## RESPONSE TO AUDIT ISSUES

### APR1400 Topical Reports

Docket No. PROJ0782

Review Section	TR Realistic Evaluation Methodology for LBLOCA of the APR1400
Application Section	Topical Report: APR1400-F-A-TR-12004 Realistic Evaluation Methodology for Large-Break LOCA of the APR1400
Issue Date	08/13/2015

Figure 1. Figure 4.4-1 of the reference [1]

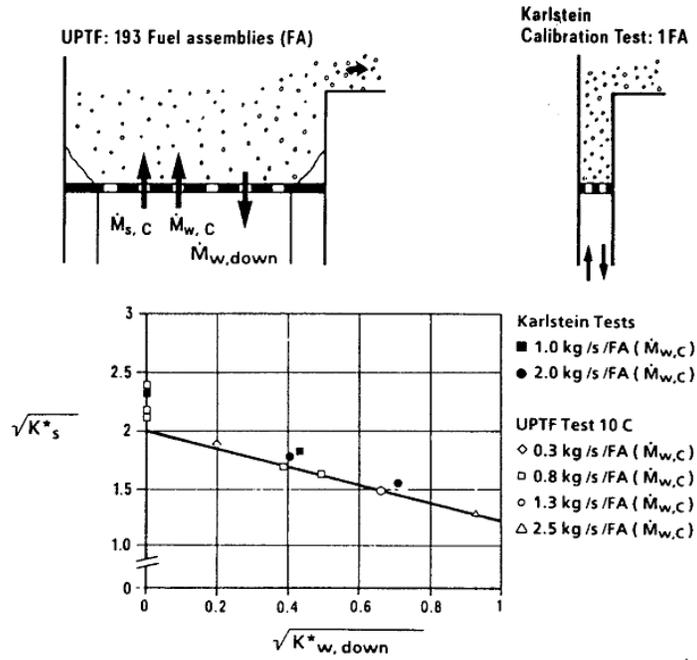
The guidance in RG 1.157, Section 3.11 establishes acceptable controls regarding the calculation of core flow distribution. Section 4.2.2.1.2 of the topical report states that the uncertainty in the high importance phenomenon of [ ]<sup>TS</sup> is not determined because it is included in the steam binding bias. Flow through the top nozzles is a complex multidimensional process with liquid down flow through the lower power outer assemblies and steam and entrained liquid up flow through the central higher power assemblies. Bias in the steam binding process is not directly related to the uncertainty in the countercurrent flow at the top nozzles. Demonstrate how the bias in the steam binding process bounds the uncertainty in countercurrent flow at the top nozzles or provide the bases for neglecting the relevant uncertainty.

Returning to the CCFL phenomena, CCFL on tie plate is very complicated hydraulic phenomena. As shown in Figure 1, CCFL phenomena consist of three flow streams, the steam and water up-flow from the core and the water fallback. RELAP5 has two fluid flow fields. Therefore, it is not easy to correctly model the CCFL phenomena with RELAP5. RELAP5 treats CCFL with a general model that allows the user to select the Wallis form, the Kutateladze form, or a form in between the Wallis and Kutateladze forms[2].

In general, experiments on CCFL are well correlated with the Kutateladze number as shown in Figure 1. Most important thing to check is the limiting gas velocity,  $v_{s,Limit}$ , above which no down-flow is possible.

$$K_{s,Limit}^* = 4.0, \text{ From Figure 1}$$
